RE: **Lot 4 Block 3 Unit 22 Volcano Cliffs SAD 228**
6324 Camino Alto
Grading and Drainage Plan
Engineers Stamp Date: 8/4/2022 (D10D003R4)
Pad Certification Date: 2/14/2023
CO Certification Date: 1/18/2024

Based upon the information provided in your submittal received 1/19/2024, this plan for Certificate of Occupancy cannot be approved until the following comments are addressed.

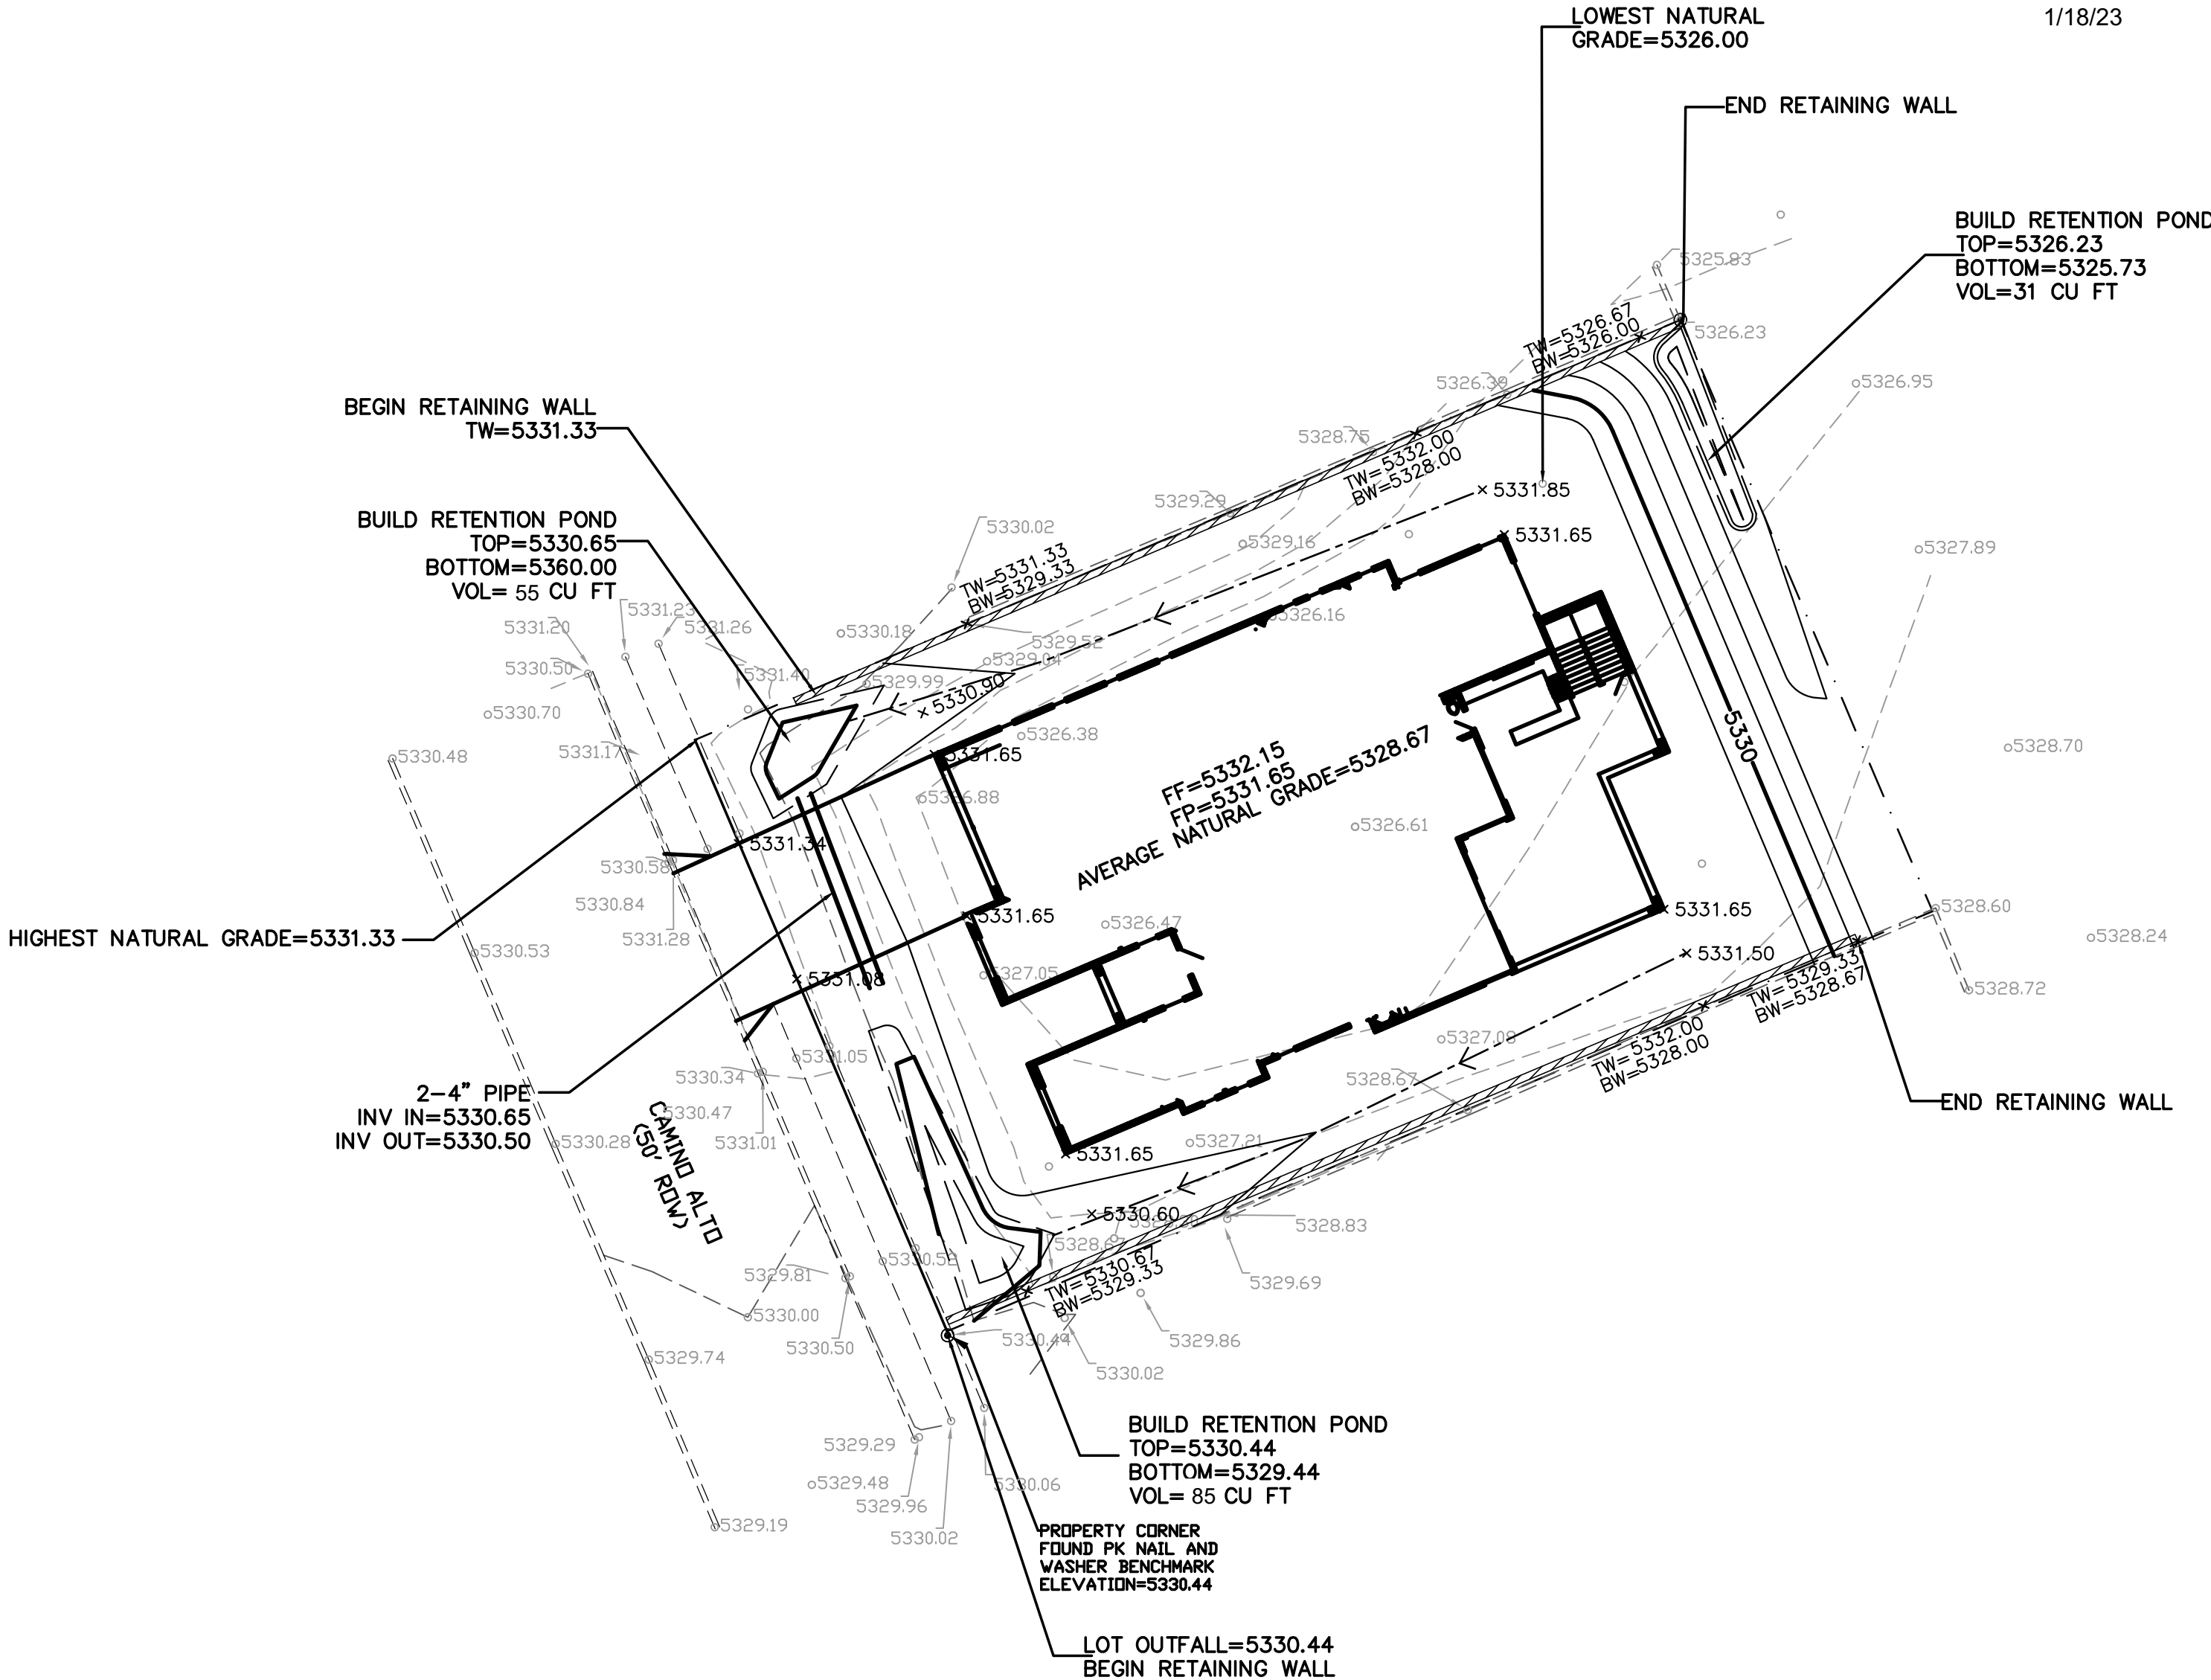
- Erosion protection must be provided in ponding areas.
- Provide erosion protection in all swales.
